CONSTRUCTION SUMMARY OF EXTRAS Printed 2020-06-09 / 2:40 PM / Page 1 of 1

Site: COOKSTOWN

Phone/Email: EATON 50-01 (B)
SOKHA KUCH & LONGRADY THAI
647-262-5880 / THAILONGRADY@GMAIL.COM

Optional Plans & Partials

COMMENTS: STOVE WALL ELEVATION

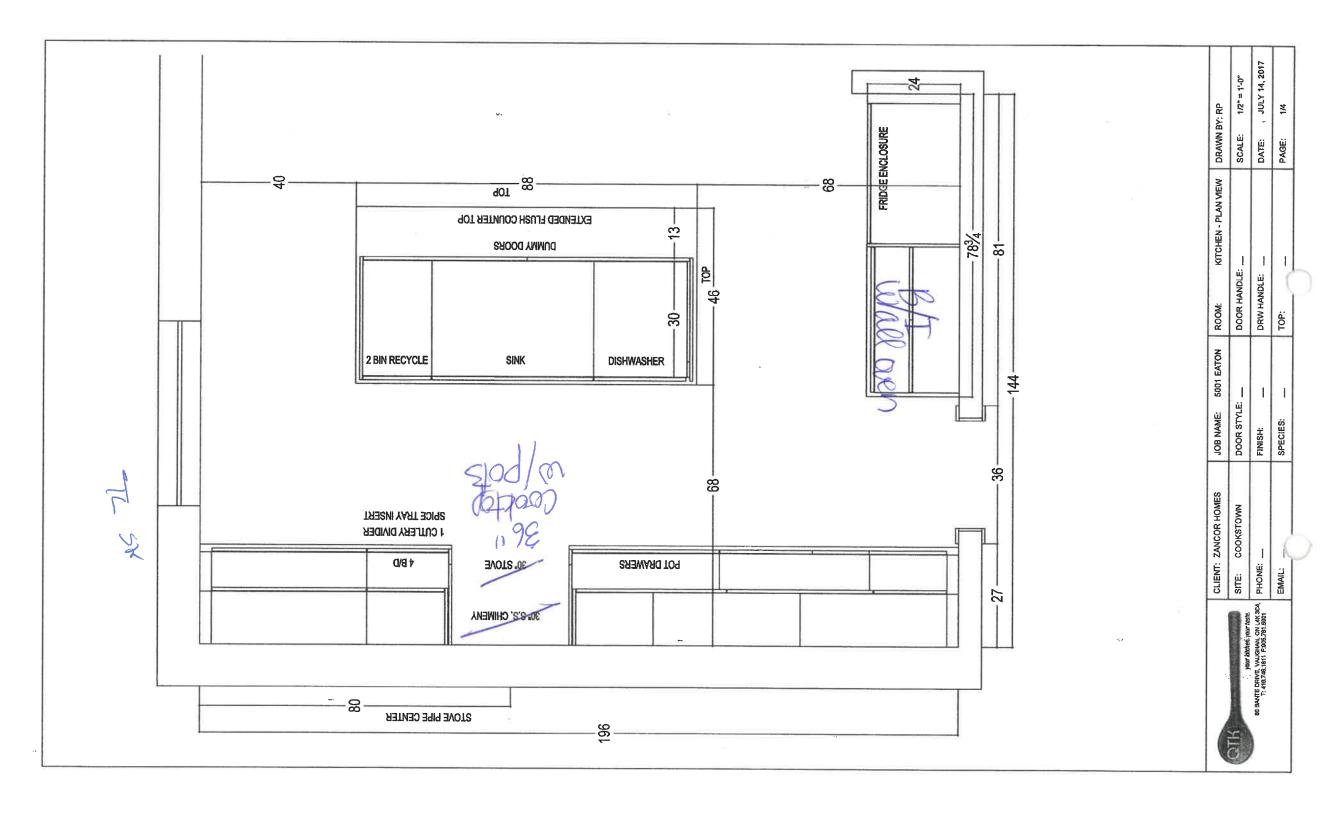
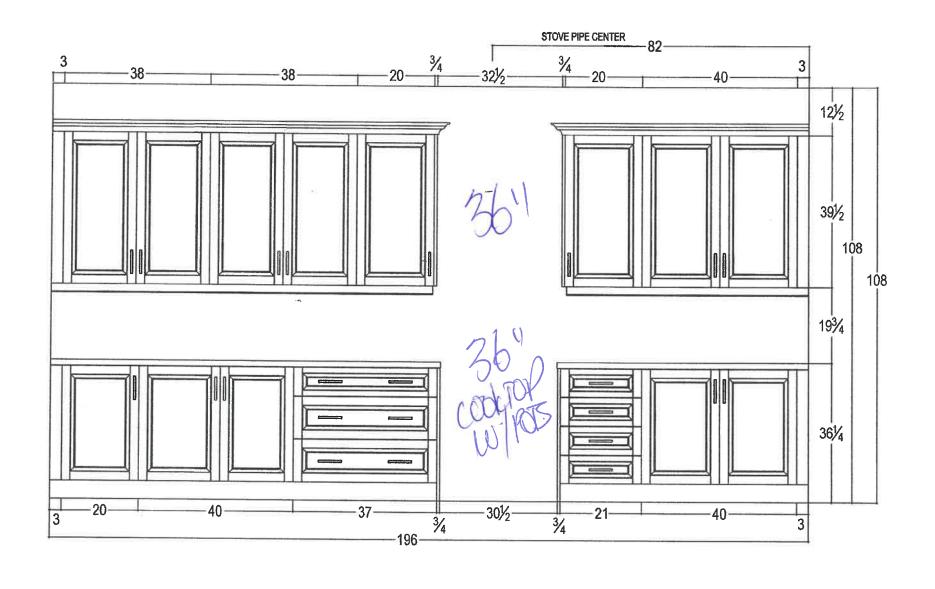
| MARCH 25 2020 | ELECTRICAL - PLUG IN MASTER BEDROOM REQUIRED AS PER ARTISTIC | #2 |
|-----------------|---|-----|
| DECEMBER 4 2019 | ELECTRICAL - FOR COOKTOP | #7 |
| DECEMBER 4 2019 | ELECTRICAL - FOR BUILT IN WALL OVEN | #6 |
| DECEMBER 4 2019 | COUNTERTOP - 36" CUT OUT FOR COOKTOP IN KITCHEN | #5 |
| DECEMBER 4 2019 | KITCHEN - BUILT IN WALL OVEN | # |
| DECEMBER 4 2019 | KITCHEN - 36" COOKTOP WITH POT DRAWERS BELOW | #3 |
